DETAILED ACTION

Response to Arguments

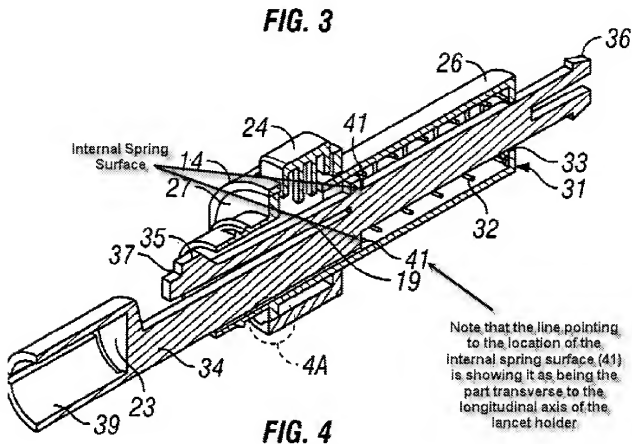
The examiner disagrees with applicant's arguments since the original disclosure only mentions the one or more spring surfaces (41) in page 9 lines 5-7 where it states "one or more internal spring surfaces 41 against which the internal spring 32 can act to propel the lancet 20" and in Fig. 4.

Applicant refers to Fig. 4 and Fig. 5 to demonstrate that there is support for the limitation (see page 16 and 17 of arguments) however it seems to the examiner that the internal spring surface is on the surface transverse to the longitudinal axis of the lancet holder (see figure below) which would cause the spring force to propel the lancet as disclosed in the specification.

Applicant is incorrect on stating that the internal spring surface is throughout the length of the lancet holder as seen in page 16 and 17 of the arguments. Note that there is no

suggestion on the original disclosure that asserts applicants arguments; therefore the rejection and objection to drawings is maintained.

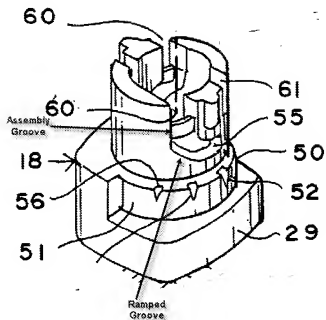
Abulhaj discloses a lancet with an adjustable depth mechanism in which a cap (18) is adjustable by a pin/groove mechanism (Fig. 15-16 where the pin (31) enters the groove seen in the figure below) where the groove has an assembly groove (see figure below) extending in a first direction (it extends longitudinally from the proximal end towards the distal end) and a ramped groove (see figure below) extending in a second direction (it extends diagonally as seen in the figure below) deviating from the first direction (see figure below).

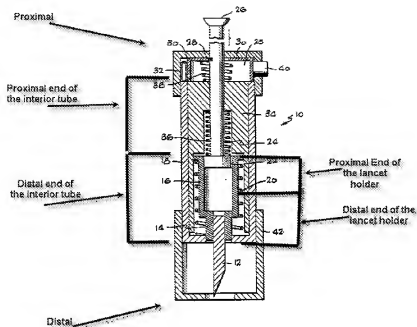
Claim 10: A rearward body assembly of a lancing device that can propel a lancet (12) into a lancing surface, the rearward body assembly comprising: a lancet holder (16) comprising one or more retaining features (14) and one or more spring surfaces (the outer area and the top surfaces of the lancet holder are spring surfaces since the surface is in contact with the springs) at the distal end (see figure below where the distal end is labeled) and one or more lancet holding features (the internal wall of 14 and 16 as seen in the Figure) at the proximal end (the proximal portion of the holding features is at the proximal end as defined in the figure below); an interior tube (34) comprising an open end (proximal end as seen in the Figure) and a slotted end (distal end where it is stepped and has an opening as seen in the Figure) through which the one or more

retaining features extend (see the Figure where it extends out when the lancet holder is propelled out), the interior tube (34) being adapted to slidably engage the lancet holder (16) (the lancet holder is placed inside the inner tube as seen in the Figure); a finger cover (18) (note that the finger cover according to applicant's drawings is a collar that goes over the interior tube as best seen in Fig. 3 of the current application) arranged along a periphery of the interior tube (see Figure); an internal compression spring (36) comprising a first end and a second end (see Figure), the first end of the internal compression spring (36) being adapted to act on the slotted end of the interior tube (34) (the proximal end of the spring is in contact with the slotted area as seen in the Figure) and the second end of the internal compression spring (36) being adapted to act on the one or more spring surfaces of the lancet holder (16) (the distal end is in contact with the lancet holder so when a force is applied on the spring it will act on the spring surfaces); a retainer (42) comprising a slotted surface (opening where the finger collar enters) at the distal end of the interior tube (see figure below) through which the one or more retaining features extend (see the Figure where it extends out when the lancet holder is propelled out); a rearward body (combination of 24 and 22), the rearward body engaging the retainer (it is indirectly engaged to the retainer); wherein longitudinal movement of the rearward body away from the interior tube compresses the interior compression spring (36) (by pulling on the rearward body it can compress the interior tube) (Col. 3 Lines 5-10) and an external compression spring (20) comprising a first end and a second end (see the Figure), the first end comprising a reduced coil diameter that engages the one or more retaining features (14) of the lancet holder (16) as seen in the

Figure, the first end of the external compression spring being adapted to act on the lancet holder (the spring is holding the lancet holder which will act on it to cause the deployment of the lancet) and the second end of the external compression spring being adapted to act on the slotted surface of the retainer (the spring is compressing on the retainer therefore it is acting on the slotted surface); and wherein the one or more spring surfaces of the lancet holder engages both the internal compression spring and the external compression spring (see Figure where the one or more spring surfaces engages indirectly to both spring).
